REMARKS/ARGUMENTS

AMENDMENTS TO THE DRAWINGS:

FIG. 2

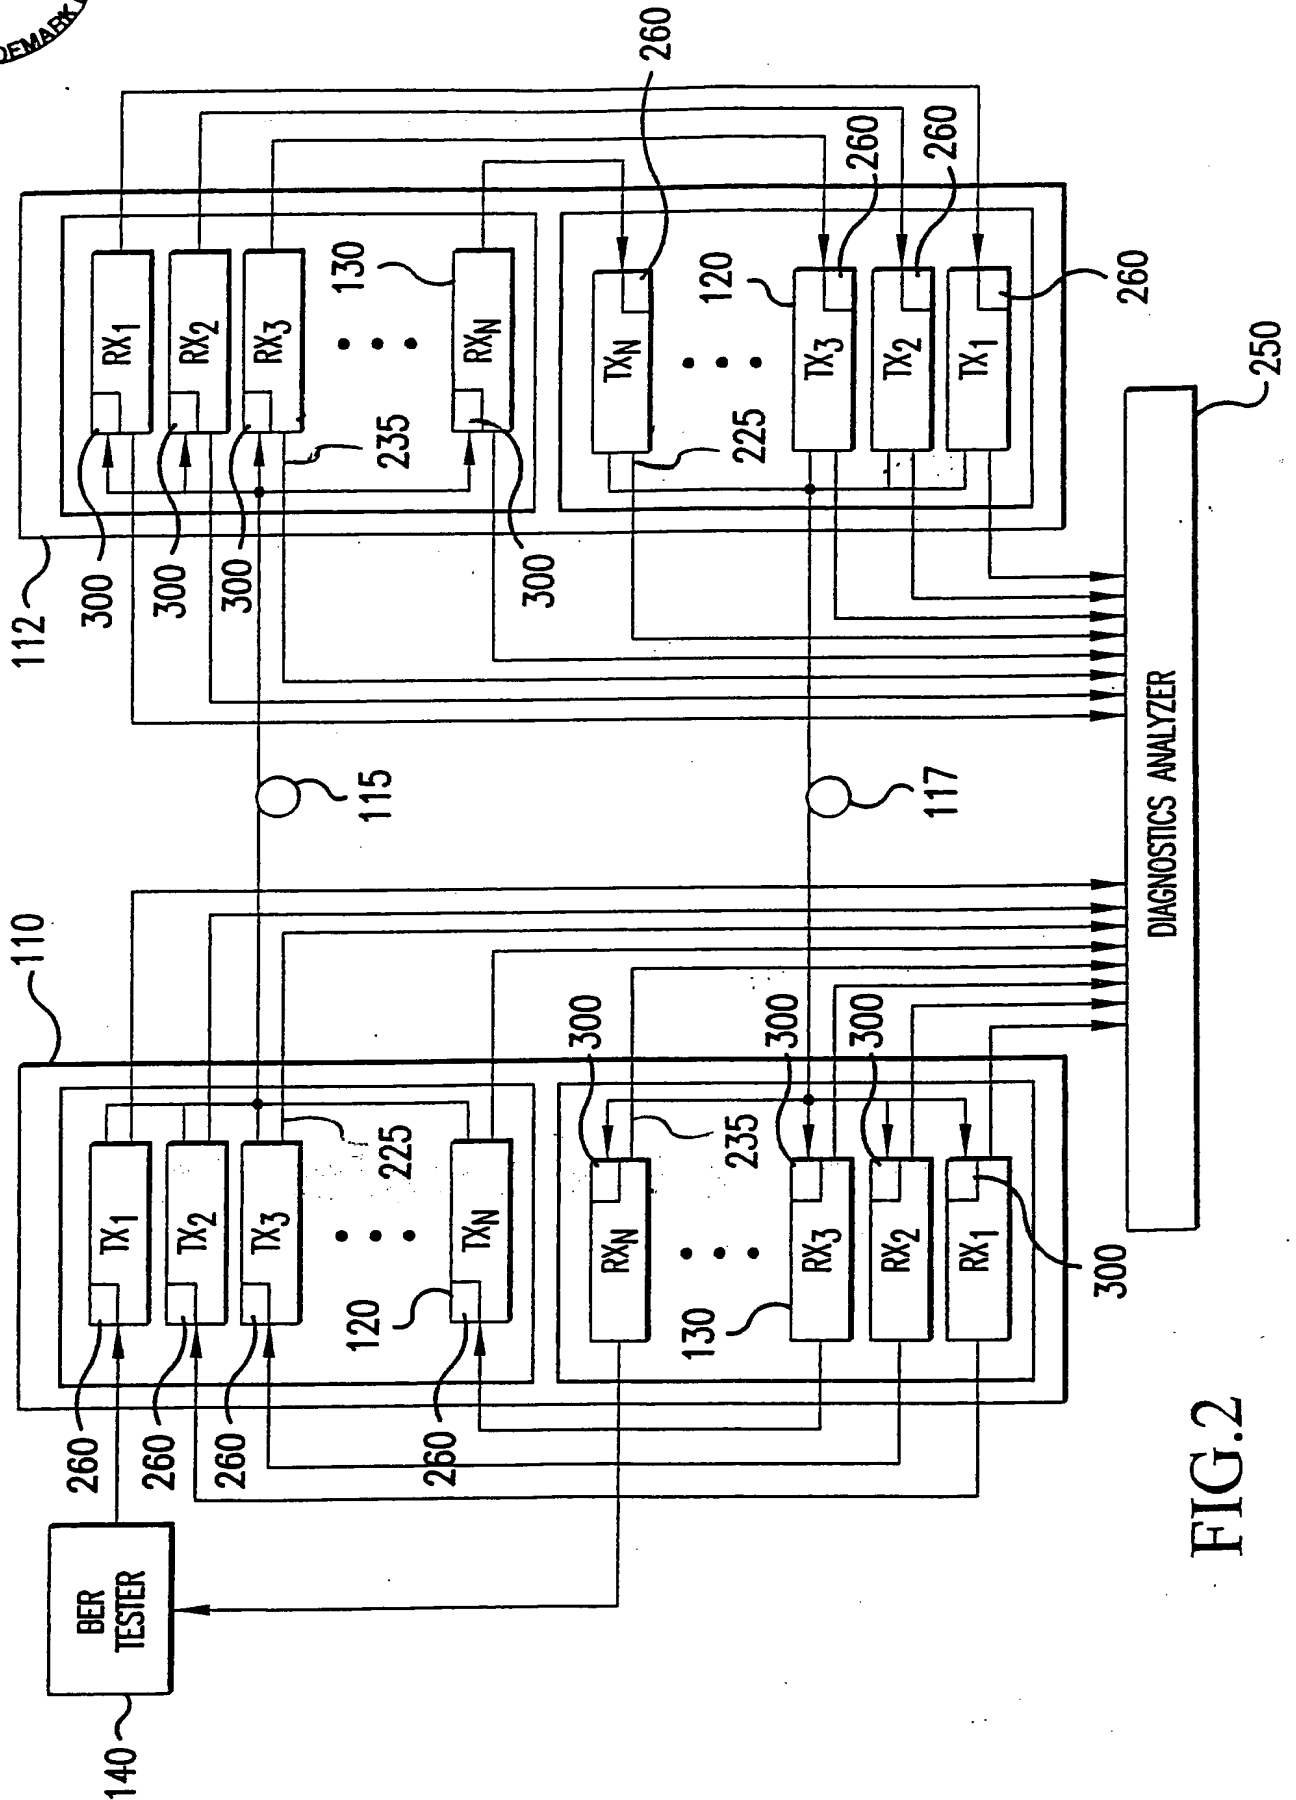
The Examiner objected to Fig. 2 because both labels "120" and "225" appear to designate transmitters units, and both labels "130" and "235" appear to designate receiver units. The Examiner further points out that page 10 of the specification describes labels "225" and "235" as referring to diagnostic output signals.

Attached herewith are formal drawing corrections to Fig. 2. In Fig. 2, the connectors for labels "225" and "235" have been changed to more clearly associate these labels with the signals output from the transmitters TX_n and receivers RX_n, respectively, to the DIAGNOSTICS ANALYZER 250. Thus, Fig. 2 has been amended to clearly show that label "225" refers to the diagnostic output signals from the transmitters, and that label "235" refers to the diagnostic output signals of the receivers.

The attached sheet of drawings includes changes to Fig. 2. This sheet, which includes Fig. 2, replaces the original sheet including Fig. 2. In Fig. 2, the connectors for labels 225 and 235 have been changed to more clearly associate these labels with the signals sent from transmitters TX_n and receivers RX_n , respectively, to the DIAGNOSTICS ANALYZER 250.
